MPC8308 Chip Errata

This document details all known silicon errata for the MPC8308. The following table provides a revision history for this document.

Figure 1. Recommended connections for DDR controller and memory

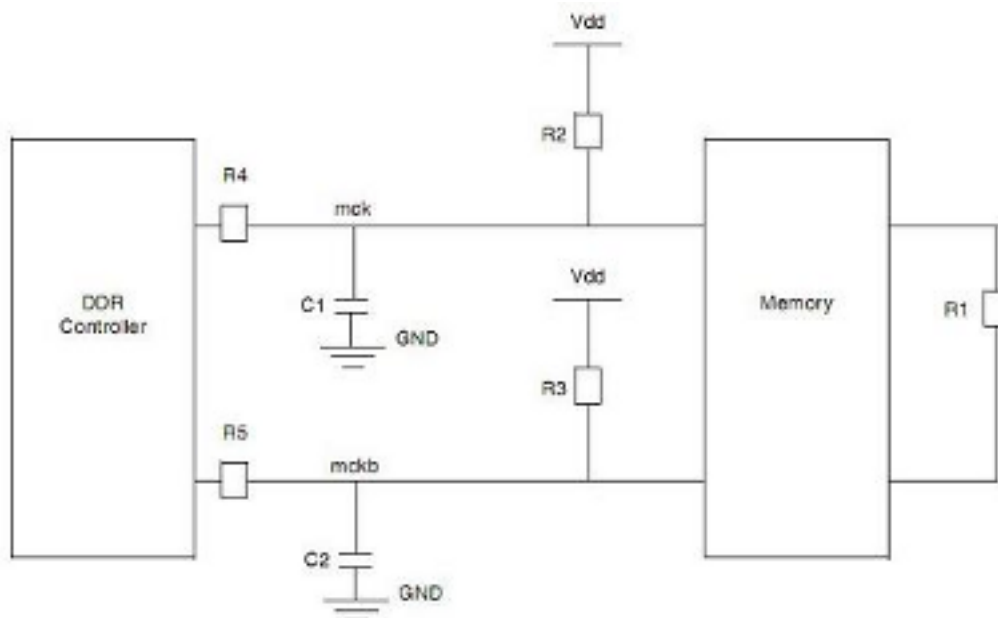
DDR21: MCK/MCK AC differential crosspoint voltage outside JEDEC specifications

Description: The crossover points of the MCK and $\overline{\text{MCK}}$ signals of the DDR controller are not meeting JESD79-2C specifications, which indicates that the crossover points should lie within ± 125 mV range of reference voltage.

Workaround: To meet the JESD79-2C crosspoint voltage specifications, we recommend implementing the following connections between the DDR controller and DDR2 memory:

Effect of different circuit components on MCK and $\overline{\text{MCK}}$ signals:

1. Increasing R2 and R3 shifts signal levels up (used as pull up).
2. Increasing C1 increases rise/fall time of mck signal.
3. Increasing C2 increases rise/fall time of mckb signal.
4. Reducing R1 can help in shifting the signals up.
5. R4 and R5 can be used to make termination proper.

R4, R5, C1, C2 near to SOC, R1, R2, and R3 have been placed at the end of clock transmission lines.

We recommend varying termination resistor R1 first. Lowering R1 can help increase the voltage levels up. The only disadvantage is that it may add up more reflections. Therefore, the user must decide accordingly. If it does not give sufficient margin, the user can add the pull-up resistor (R3 and R4) option to further increase the voltage levels.

Exact values of components vary from design to design and some of them may not be required for all designs. We recommend that you make provisions for all these options in your design.
